V2500-A5 SERIES PROPULSION SYSTEM SERVICE BULLETIN

This document transmits the Initial Issue of Service Bulletin V2500-ENG-73-0207.

ENGINE – FUEL AND CONTROL – PROVIDE A NEW TWO POINT TRIM ENGINE PRESSURE RATIO (EPR)
CLASSIFICATION FOR ELECTRONIC ENGINE CONTROL (EEC) UNITS WITH SCN20A SOFTWARE

FIGURE 1, SHEET 1

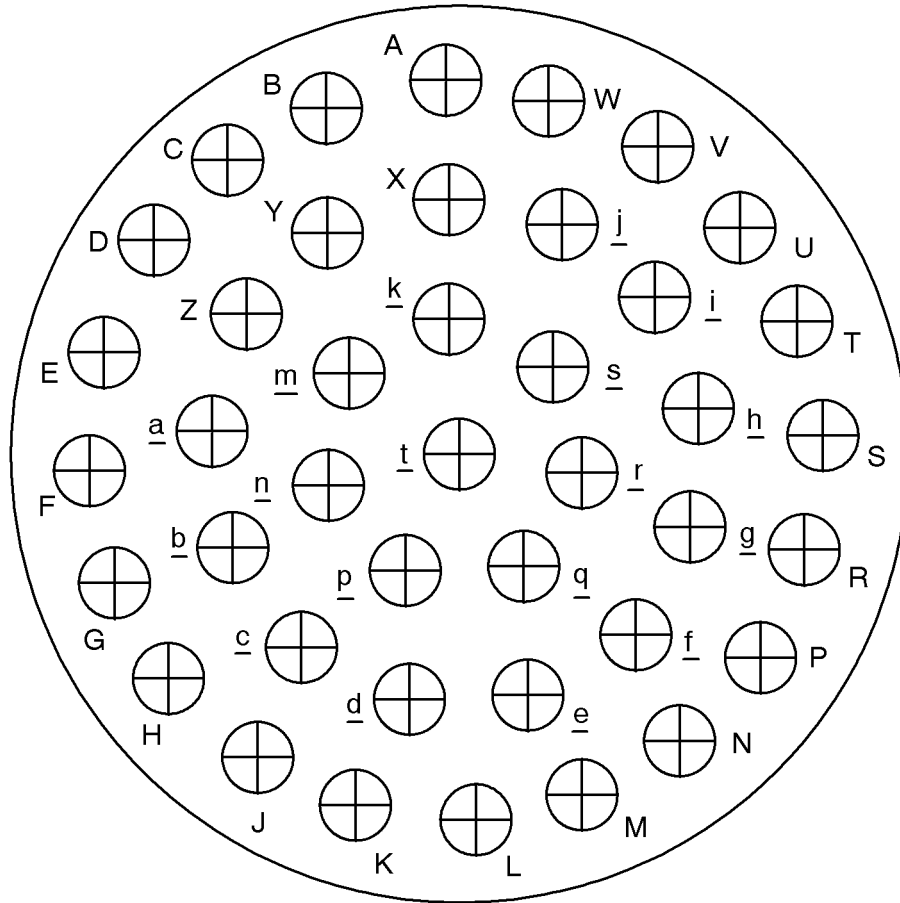
- Remove the Data Entry Plug Assembly, PN 2A3106 by the procedure in Reference 4, Aircraft Maintenance Manual, Chapter/Section 73-22-35, Removal of the Data Entry Plug Assembly. See Figure 1, Sheet 1 for the location of the data entry plug assembly.
- Put a plastic cap on the EEC connector. This gives the EEC protection from unwanted fluids or materials.

- (3) Use a Strap Wrench, TG-70 or equivalent, to loosen the backshell nut. Remove the backshell from the DEP connector. See Figure 1, Sheet 1 for the location of the nut.

LOCATION OF THE DATA ENTRY PLUG (DEP) ASSEMBLY AND CONTACT HOLE LOCATIONS
FIGURE 1, SHEET 2

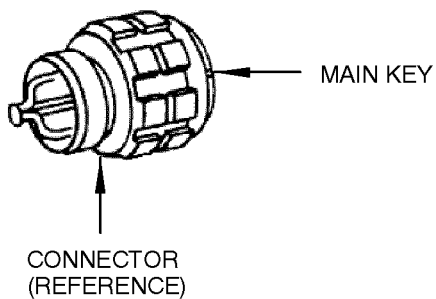
(e) Remove the jumpers, sealing plugs and contact pins from the connector. See Figure 1, Sheet 2.

NOTE: It is recommended that you make a copy of the diagram of the contact hole locations in Figure 1, Sheet 2 and mark the necessary jumpering connections on the diagram.

DISASSEMBLY OF THE DATA ENTRY PLUG (DEP) ASSEMBLY
FIGURE 2

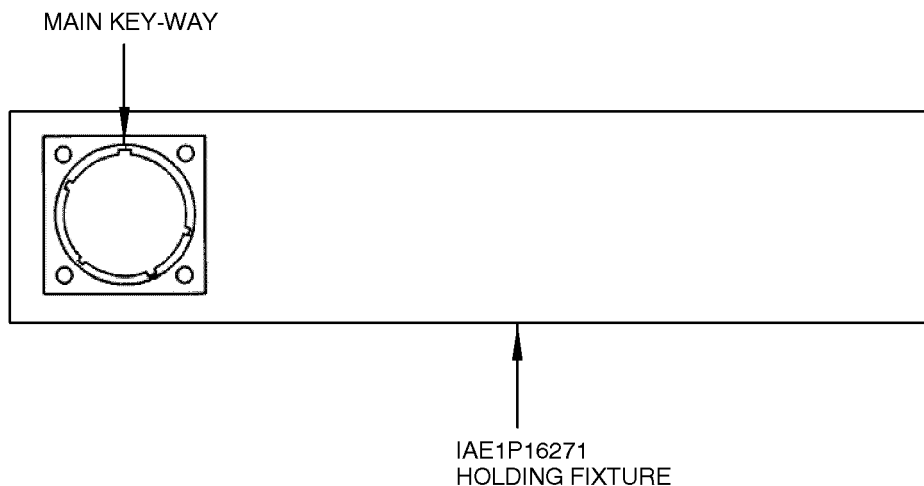
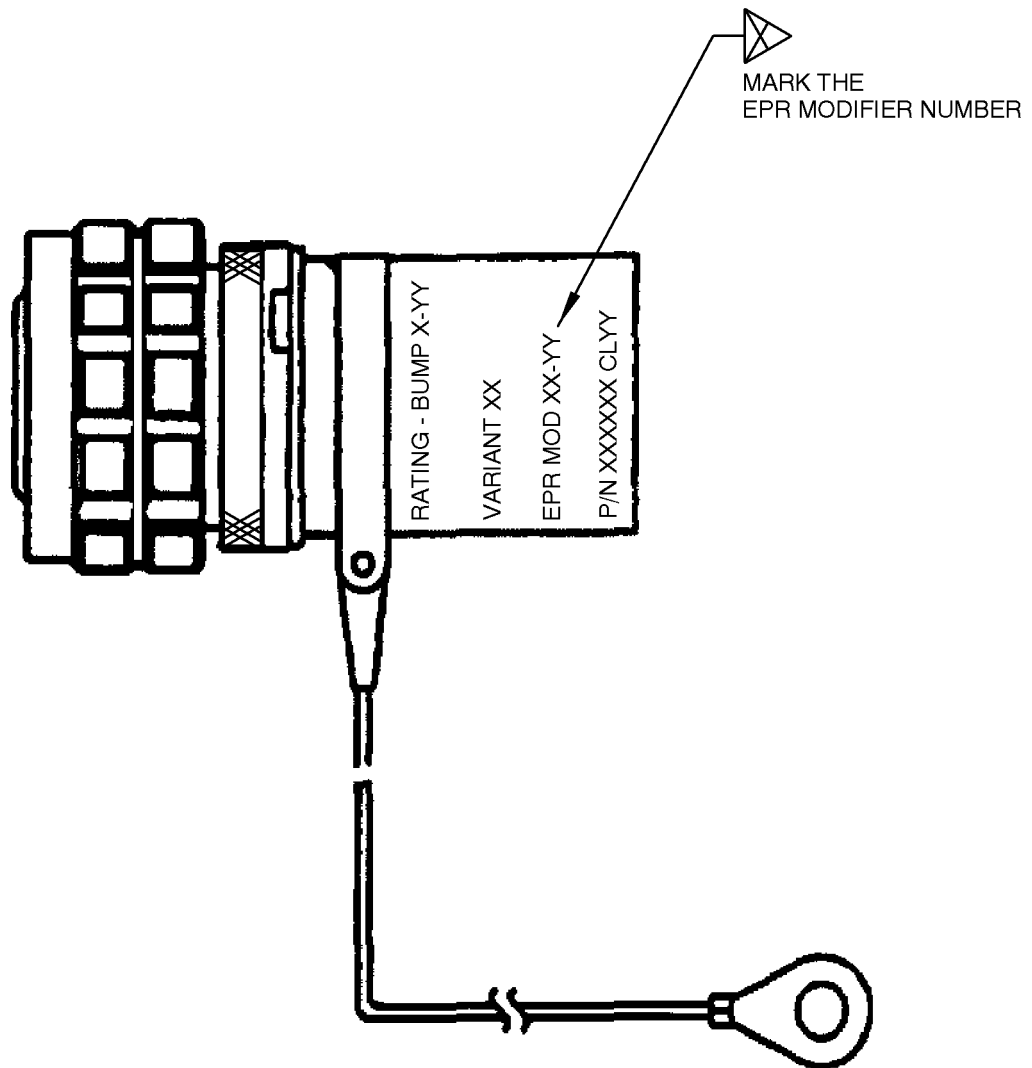
- (i) Remove and discard the lockwire which safeties the nut to the backshell.
- (ii) Install the DEP onto Holding Fixture, PN IAE1P16271 and disassemble it as follows. See Figure 2
 - (1) Align the main key on the connector with the main key-way on the holding fixture.
 - (2) Use light hand pressure to engage the DEP with the holding fixture and tighten it by hand.

(i) Install the backshell to the connector. See Figure 1, Sheet 1 and Figure 2

MARKING OF THE BACKSHELL
FIGURE 3

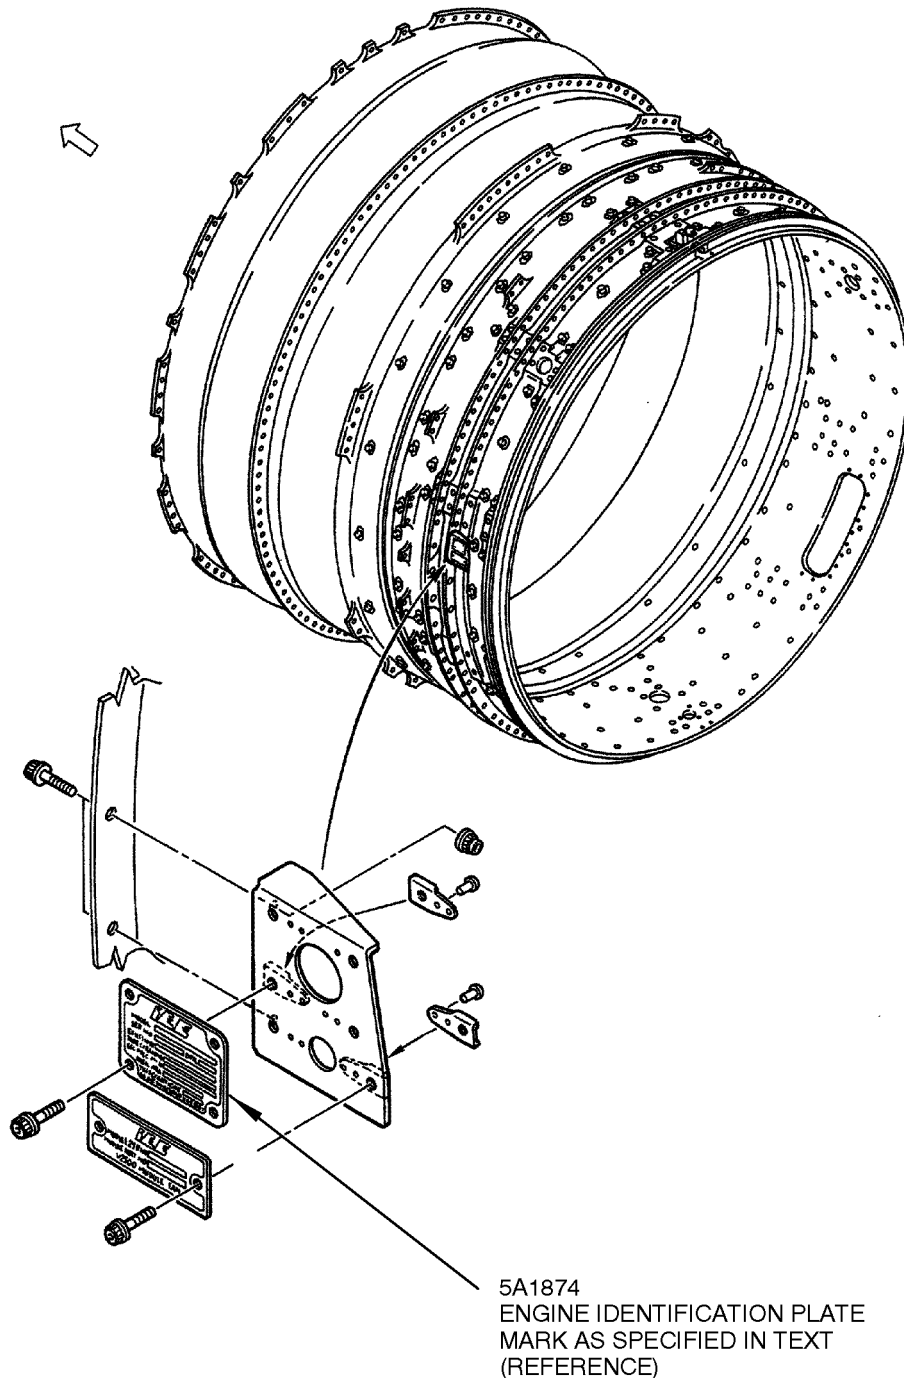
- (h) Make marks on the backshell outer face and on the engine identification plate. See Figures 3, 4 and 5

- (i) Mark the new EPR modifier on the backshell and the engine identification plate using the vibration peen method. See Reference 5, Standard Practices Manual, Chapter/Section 70-09-00, Marking of Parts. The EPR modifier number and EPR class bias must be as follows:
